Appendix P3 –  
Recommended Road  
Safety Policies and  
Practices – CASR

## Recommended road safety policies and practices for Kangaroo Island Plantation Timbers

This report results from an investigation into the safety aspects of a proposed Performance Based Standards (PBS) Level 2B route between the Kangaroo Island Plantation Timber (KIPT) hardwood timber plantations in the west of the island and KIPT's proposed new port at Smith Bay on the North Coast. The report focuses on two final options between Parndana and Smith Bay, along with extensions of the routes along Playford Highway and Mount Taylor Road. A total of nine options for the route between Parndana and Smith Bay were presented in earlier reports by KIPT and its consultants, but were reduced to two for consideration in the project brief received from Kangaroo Island Council.

**Photo No. 14 – Item 44, tight horizontal curve on North Coast Road.**

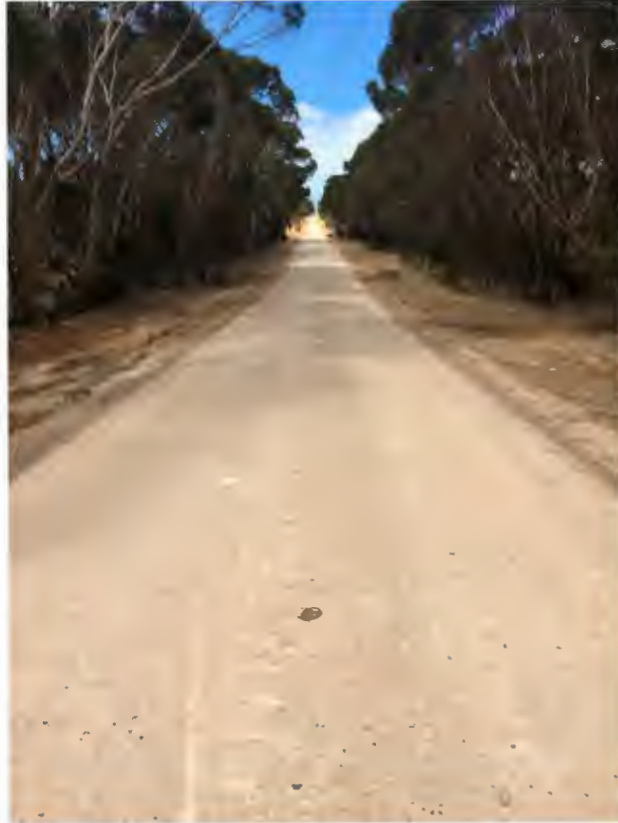
44.	There is a horizontal curve at Ch 16.0, estimated radius 80m (worst section), with 8.3m carriageway. Table 5 in the PBS Guidelines indicates a 1.15m curve widening per lane, therefore a 10.0m carriageway width should be provided around this curve. This is a dangerous curve with a crest also present, trees 2.5m from the edge and some CAMs provided. See Photo No. 14.	<b>Possibility</b> Possible <b>Exposure</b> Rare <b>Consequences</b> Very Serious <b>Risk Score</b> P2	Widening of the pavement by 1.7m is required on this curve to provide required curve widening.  Consideration should be given to improving the alignment along this section of road, this is a very tight radius.	\$15,000 Residual Risk P3 1.7m x 300m = 510m <sup>2</sup>

**Photo No. 21 – Item 69, single lane bridge on Ropers Road.**

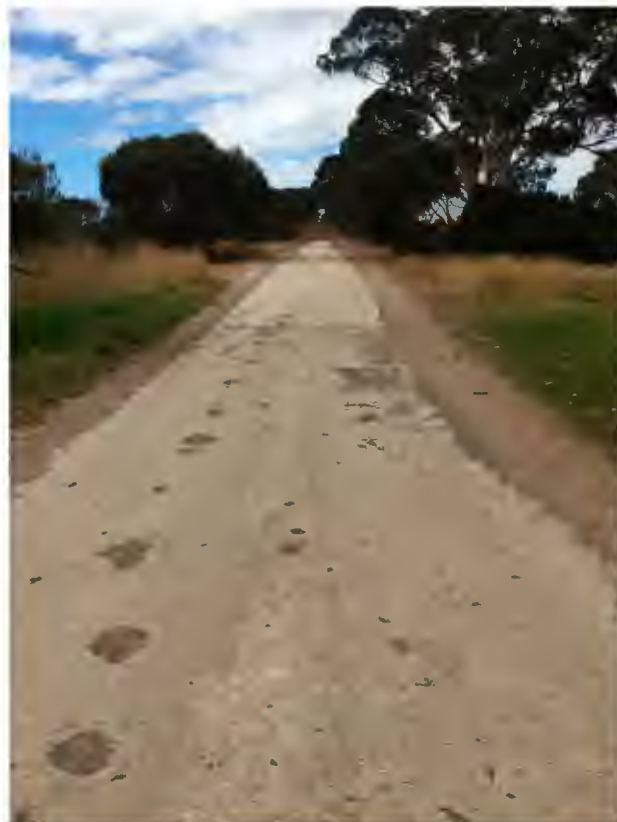
69.	<p>At Ch 3.1 there is a bridge, the sign warns that it is only 'one lane' width on the bridge, kerb to kerb is 3.5m, the bridge is 18m long. Sight distance is alright mainly given vehicles are travelling very slowly, one of the approaches to the bridge has an estimated radius of 300m.</p> <p>See Photo No. 21.</p>	<p><b>Possibility</b> Likely <b>Exposure</b> Frequent <b>Consequences</b> Fatality <b>Risk Score</b> P1</p>	<p>The bridge requires widening to bring it up to the correct width to allow two vehicles to pass each other at the same time.</p>	<p>\$350,000 Residual Risk P3</p>

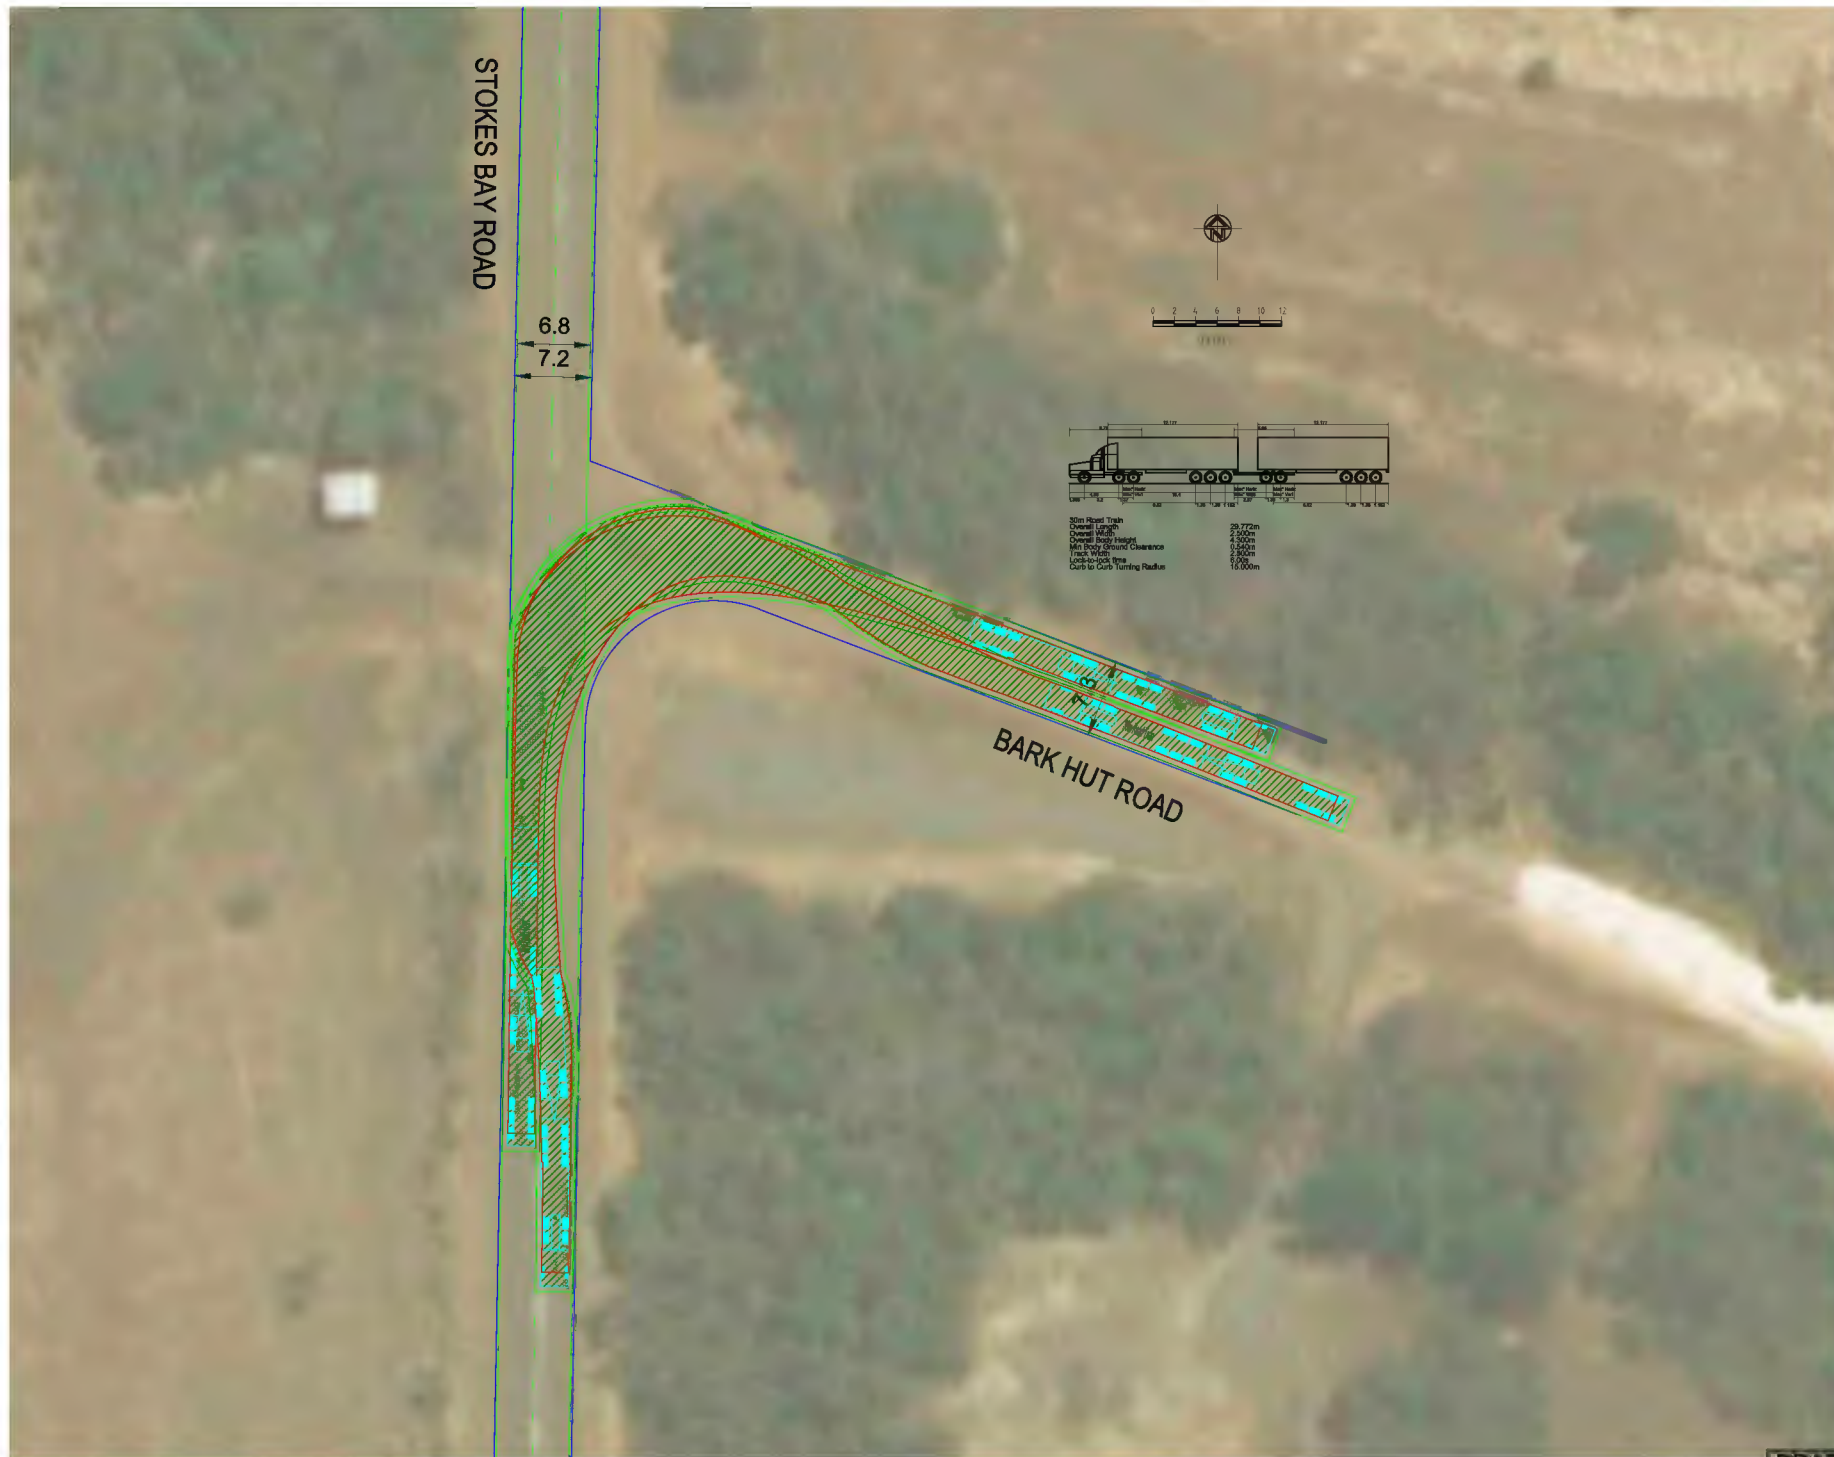
1.	<p>The 30m A-Double Short Road Train PBS Level 2B turning movement at the intersection of Playford Highway and Stokes Bay Road is shown on Drawing SK03 in Appendix B. It identifies that this junction has insufficient width to accommodate all turning movements.</p> <p>There is a culvert close to the junction on Stokes Bay Road which may need to be widened to accommodate the movements. Currently there is only 9.6m between the headwalls of the culverts.</p> <p>Sight distance along Playford Highway from Stokes Bay Road is reasonable in both directions at approximately 17s to the right and similar to the left, vegetation clearance would improve it.</p> <p>See Photo No. 1.</p>	<p><b>Possibility</b> Unusual but Possible</p> <p><b>Exposure</b> Frequent</p> <p><b>Consequences</b> Very Serious</p> <p><b>Risk Score</b> P2</p>	<p>A significant upgrade is required for this junction to be able to accommodate PBS Level 2B turning movements safely. Considerable widening is required, along with the lengthening of culverts.</p>	<p>\$300,000</p> <p>Residual Risk P3</p>
